## **Service Bulletin**

**No. :** MZ08-025\_2nd

**Model:** SA-7S1, SA-11S2

**Subject:** Irregular operation improvement by static electricity

## HOW TO INSTALL A LEAF SPRING AND REPLACE THE SHAFT-GUIDE-R (POS. NO. 16)

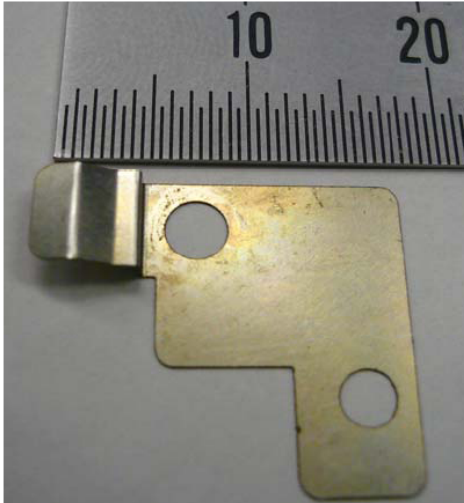
1) LEAF SPRING

2) SHAFT-GUIDE-R (POS. NO. 16)

The depth of the recess on this surface has been changed to 0.1mm.

HOW TO REPLACE THE SHAFT-GUIDE-R (POS. NO. 16)

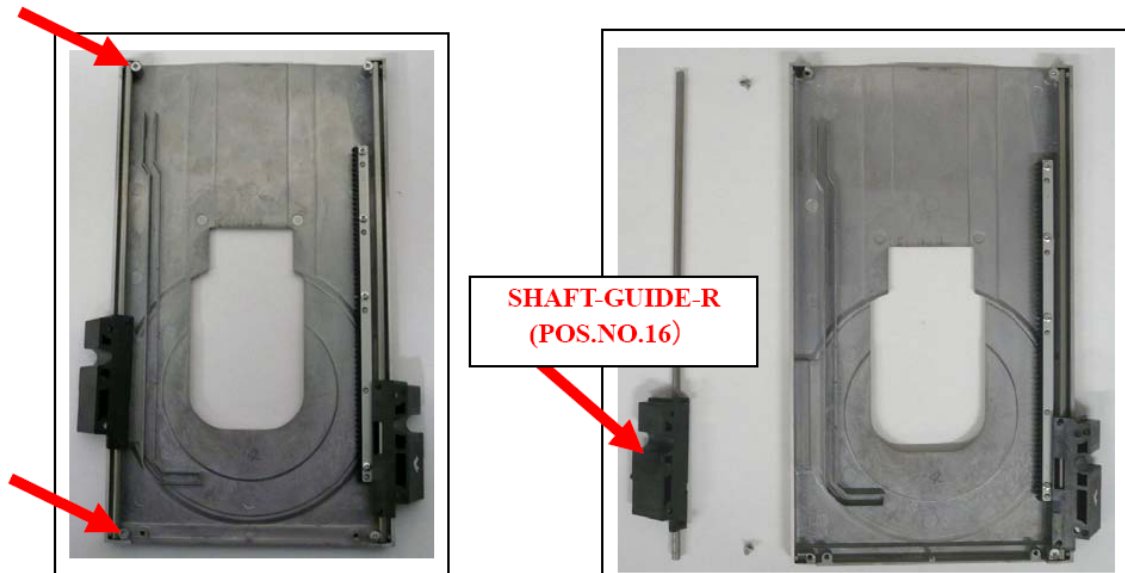
7. Take out the two screws that hold the TRA-SHAFT.
8. Replace the SHAFT-GUIDE-R (POS. NO. 16).

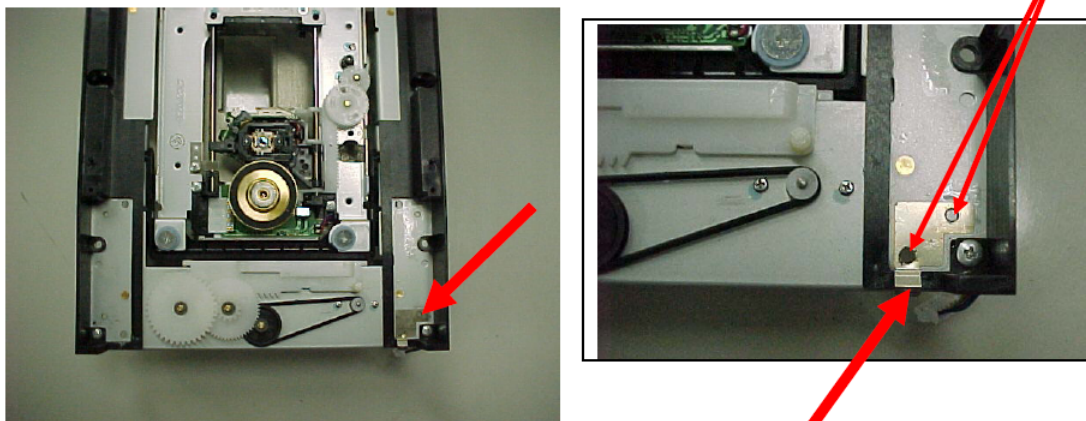
9. Place the LEAF SPRING in the position shown in the picture below. Match the two holes of the chassis and those of the LEAF SPRING.

**This part contacts the SHAFT, thereby grounding the TRAY.**
